ADDENDUM NO. 2

for
**PUBLIC ADDRESS AND CLOCK SYSTEM REPLACEMENT AT VARIOUS
MANALAPAN-ENGLISHTOWN REGIONAL SCHOOLS**
School, 118 Millhurst Road, Manalapan, NJ 07726

Issued: May 1, 2026

FVHD PROJECT NO. 5618

PINE BROOK ELEMENTARY SCHOOL
ELECTRICAL NEW WORK - PARTIAL FLOOR PLAN - BLOCK "A"

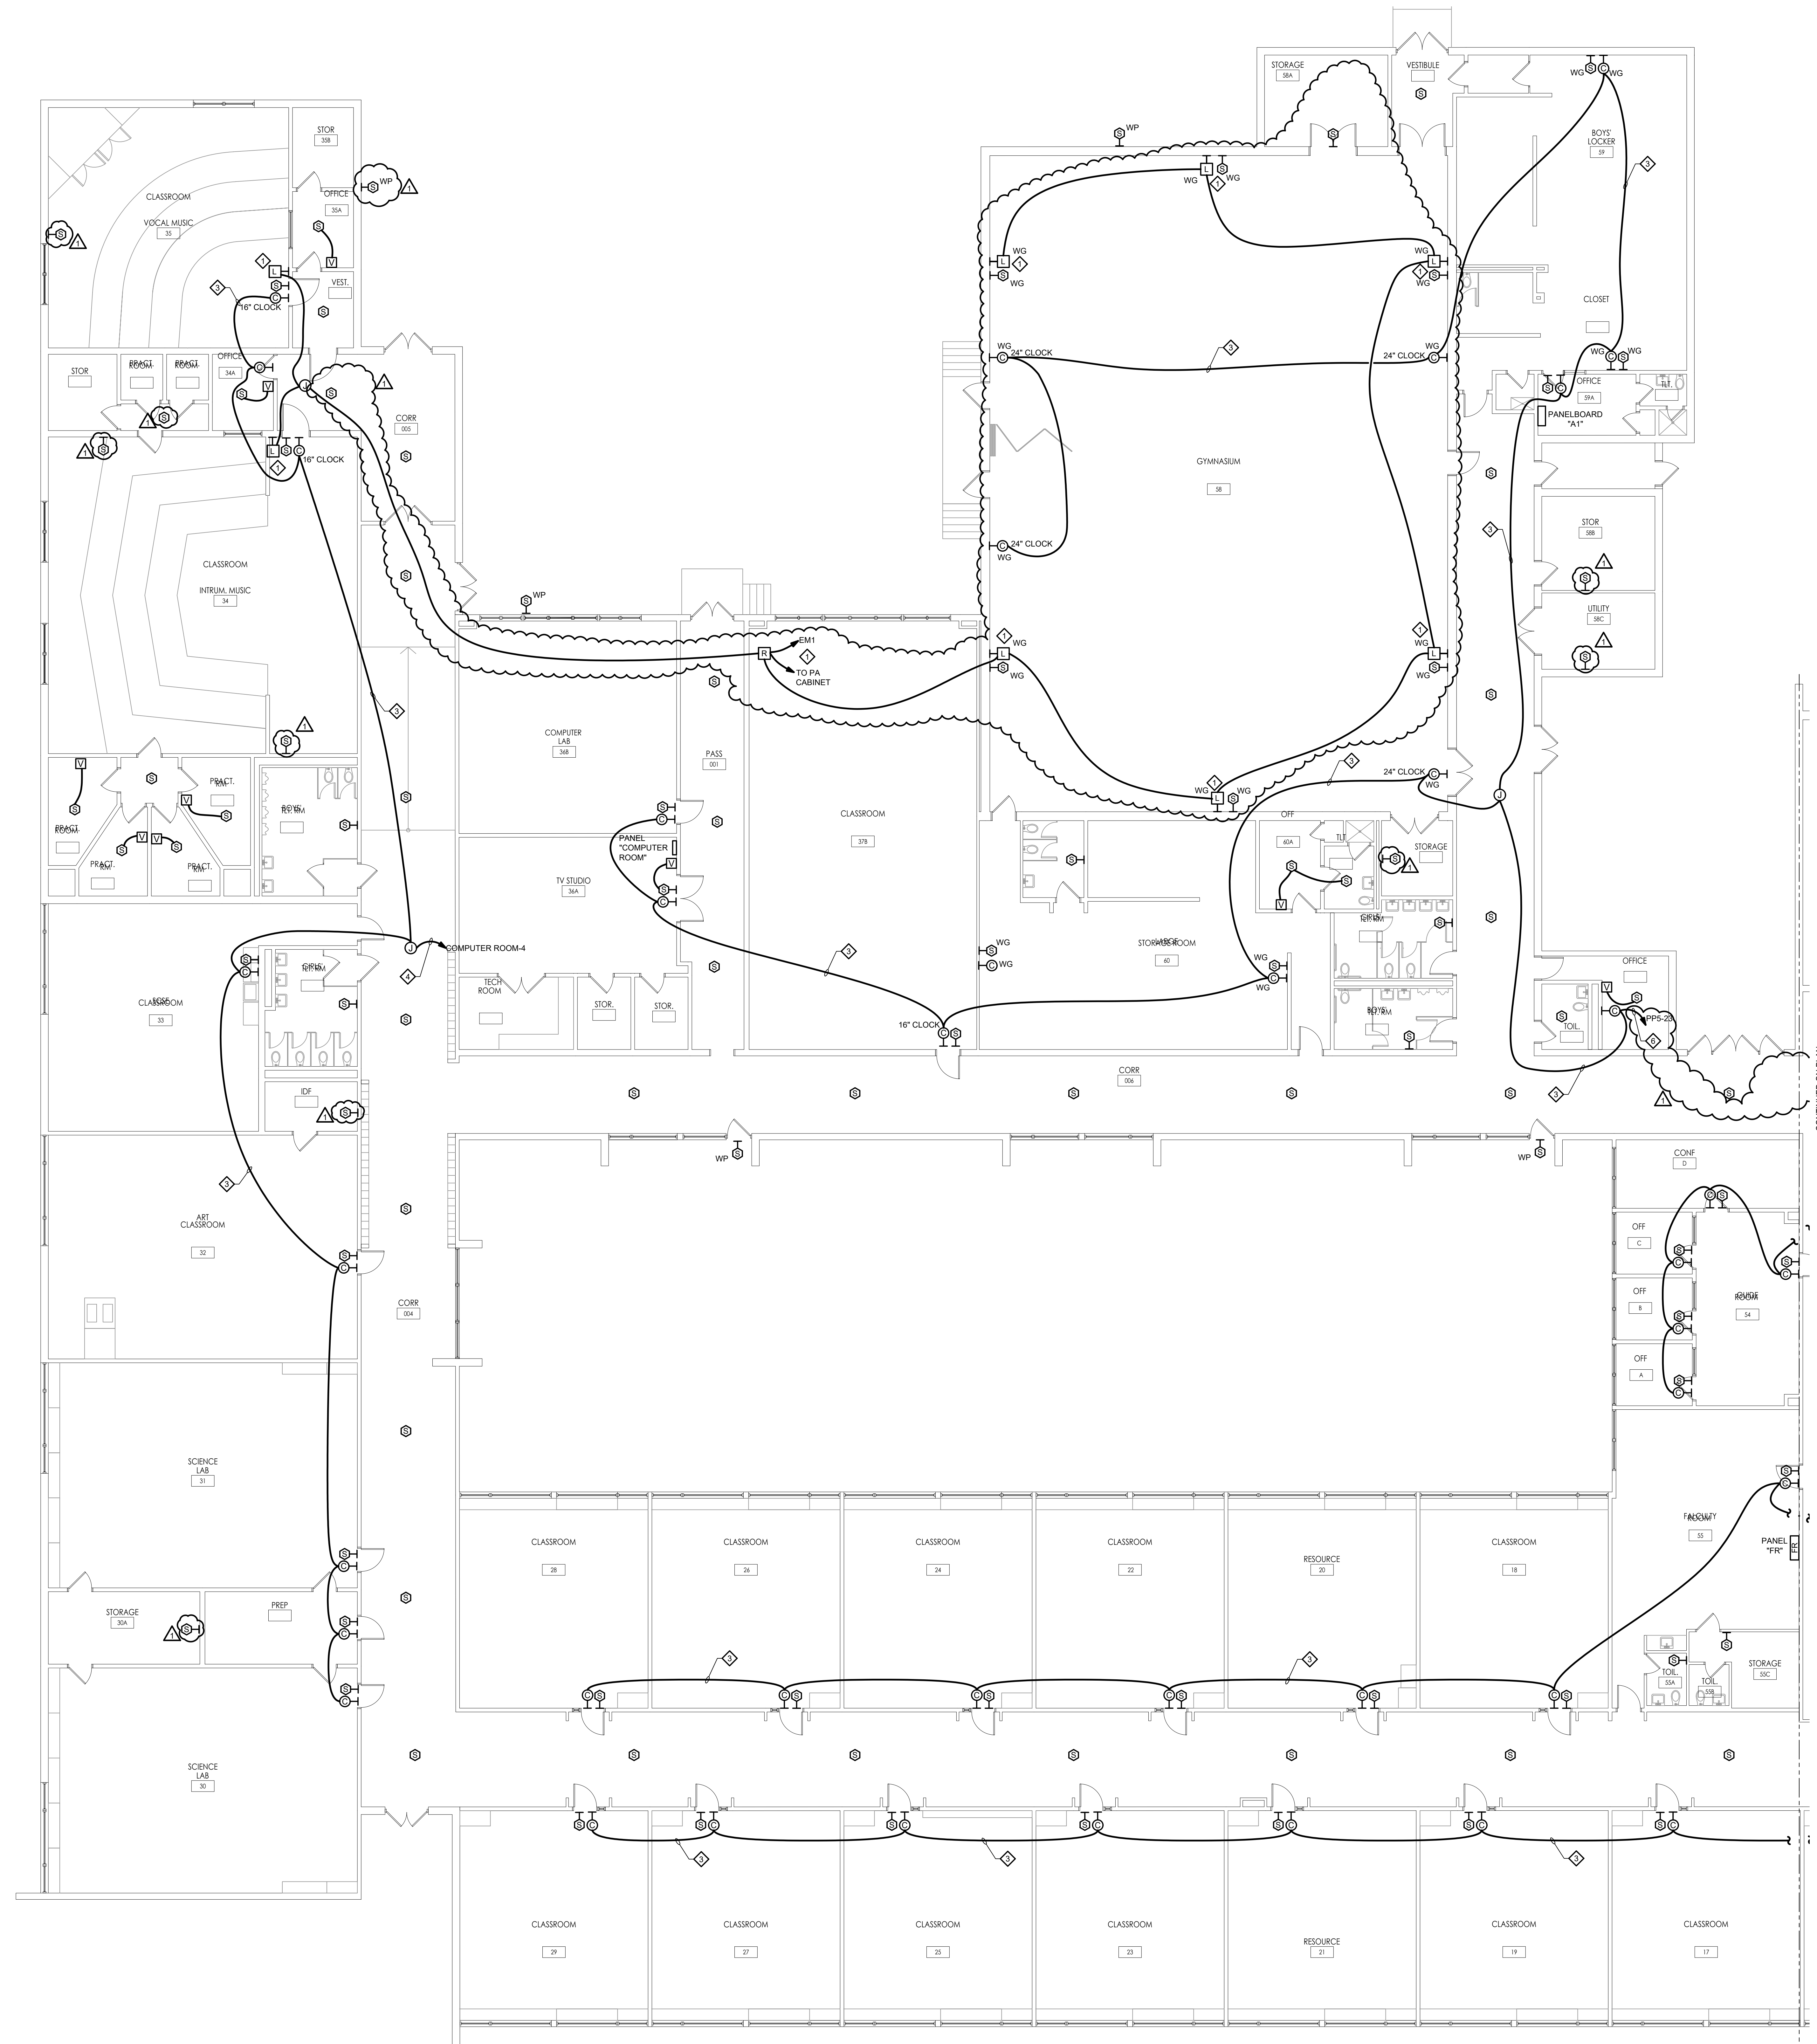
- 2.1.8 Removed Milford Brook Drawings E101MB, E102MB, E201MB, E202MB, E601MB.
- 2.1.9 Pine Brook Drawings E101PB, E102PB, E201PB, E202PB, E601PB: Revised as indicated.
- 2.1.10 Removed Taylor Mills Drawings E101TM, E102TM, E103TM, E201TM, E202TM, E203TM, and E601TM.
- 2.1.11 Removed Wemrock Brook Drawings E101WB, E102WB, E103WB, E104WB, E105WB, E201WB, E202WB, E203WB, E204WB, E205WB, and E601WB.

Drawing Number
E202PB

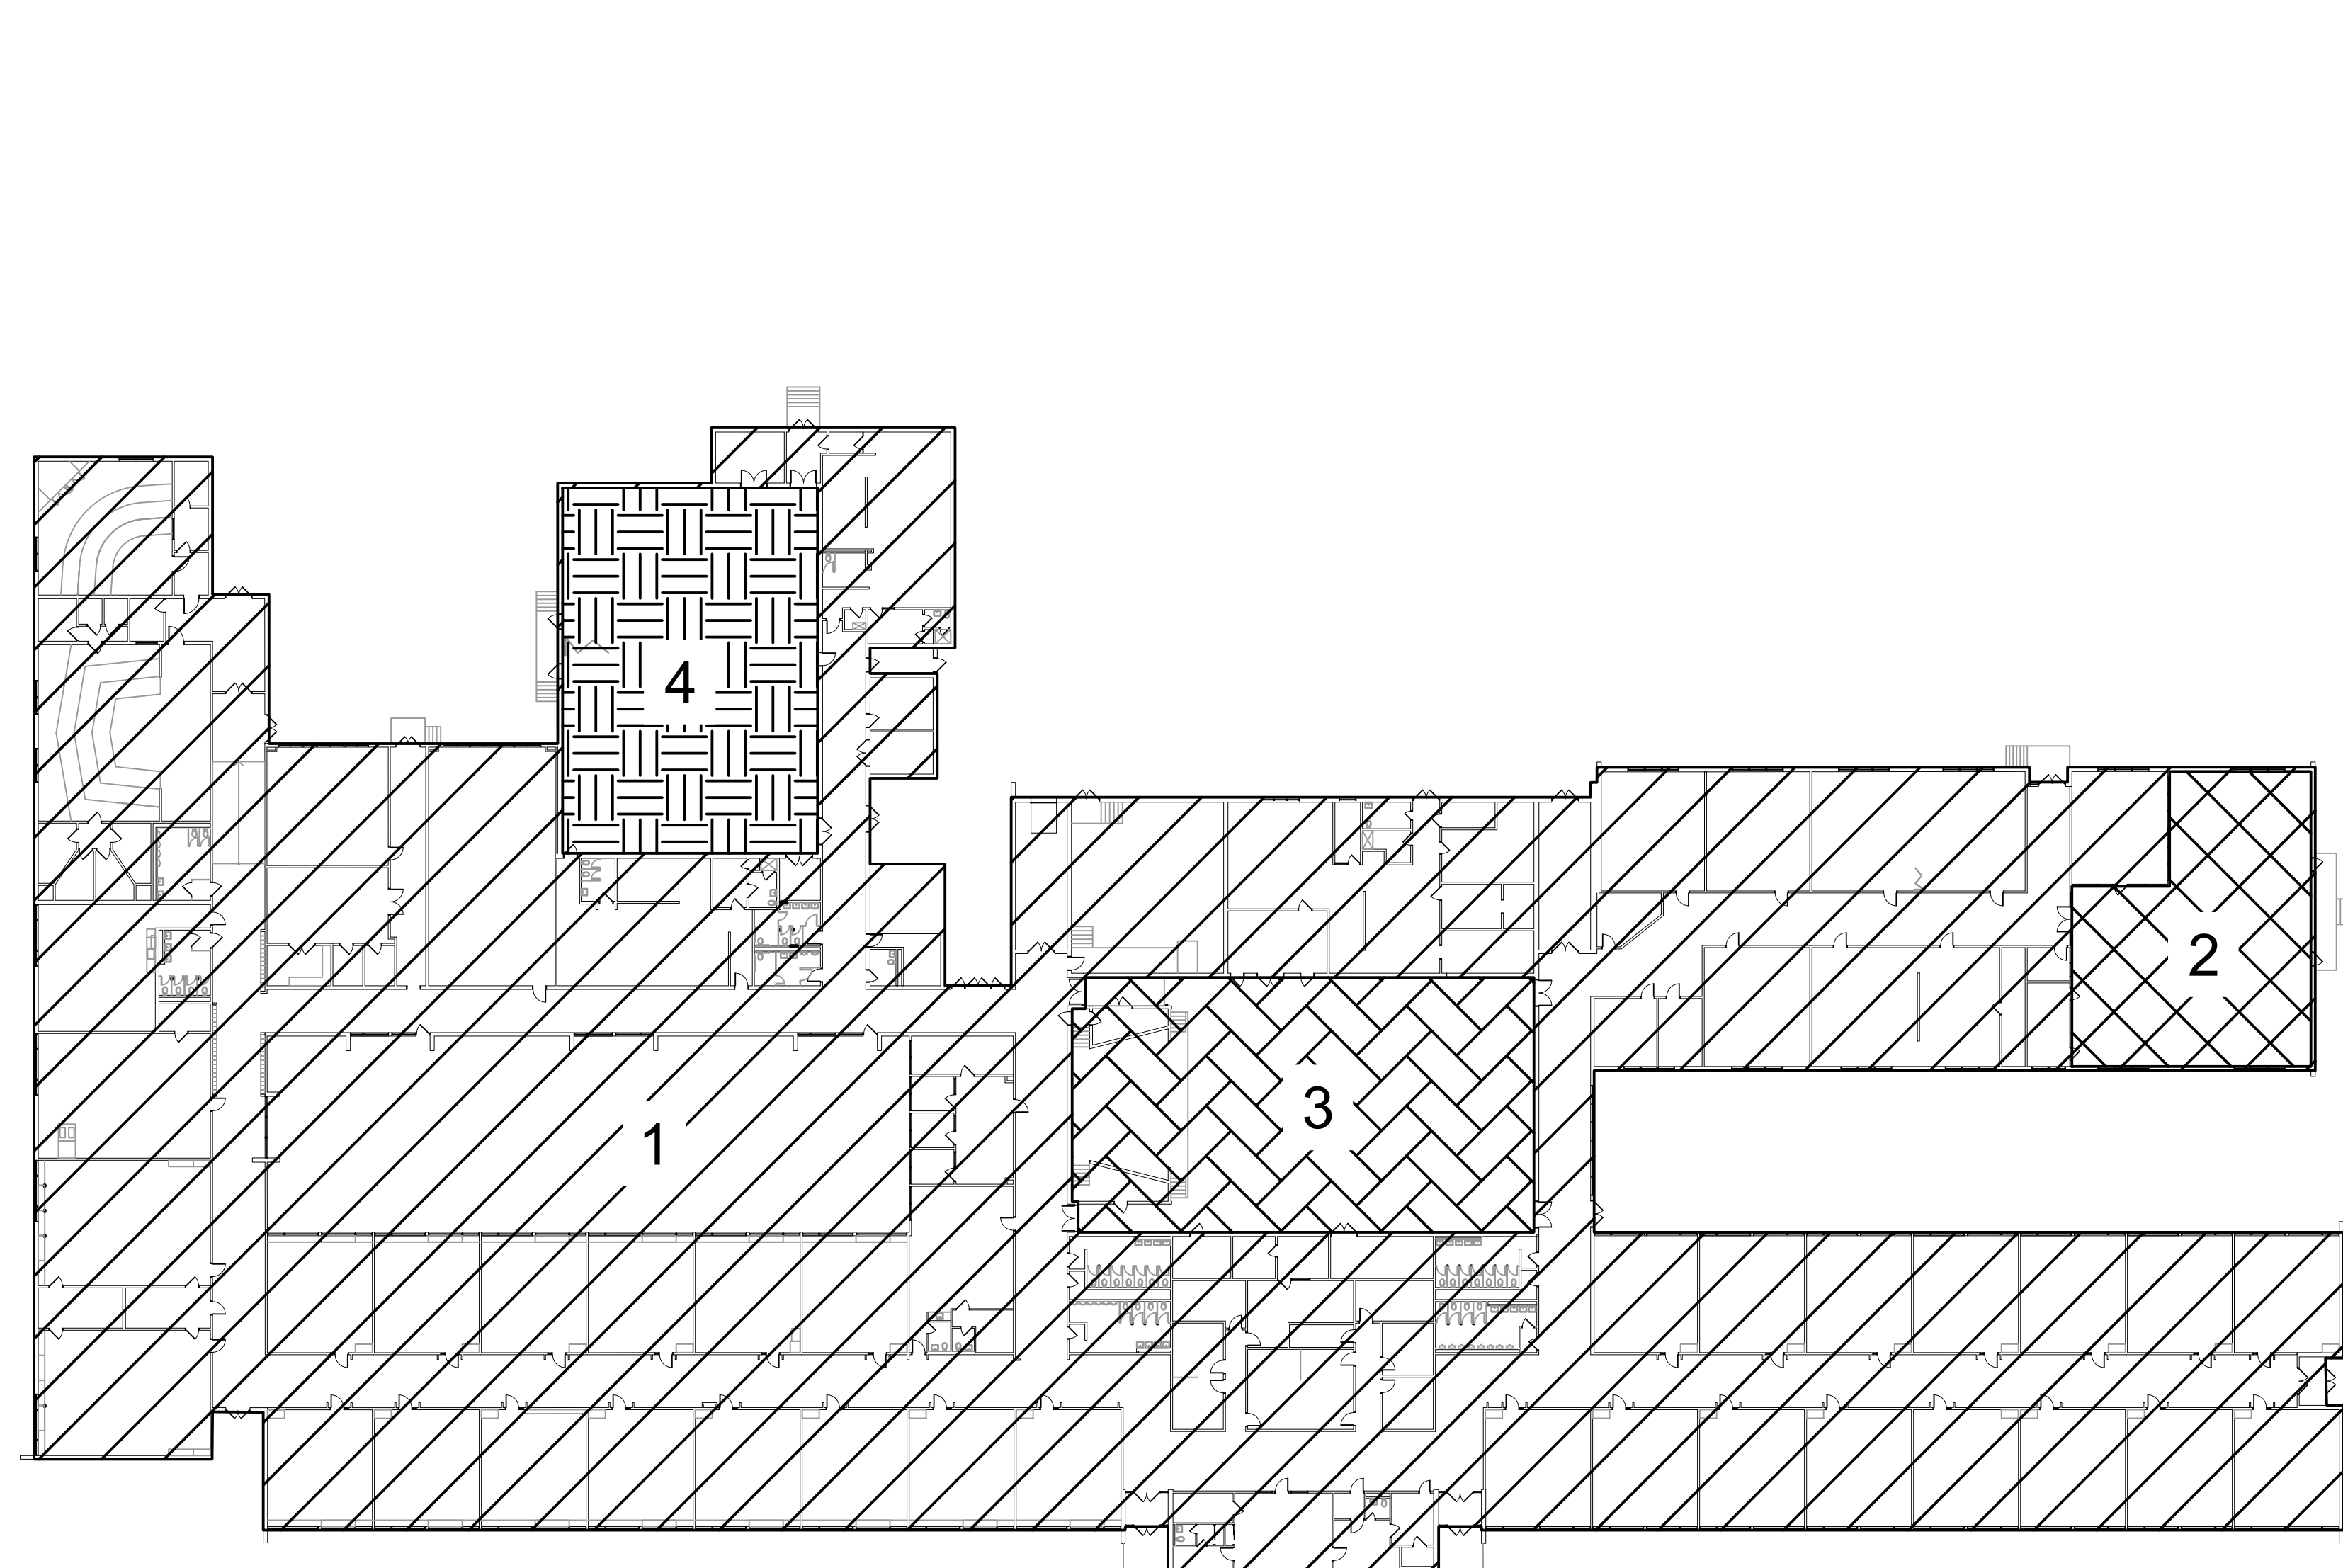
Response: Volume controls are required where shown on the drawings.
5. Question: On Pine Brook Drawing E202PB, please confirm the required clock size for the southeast cafeteria location (9" vs. 24").

Response: This has been addressed in the Addendum drawings and specifications.
6. Question: Please confirm whether the new PA system is required to integrate with any existing or planned emergency notification or lockdown systems.
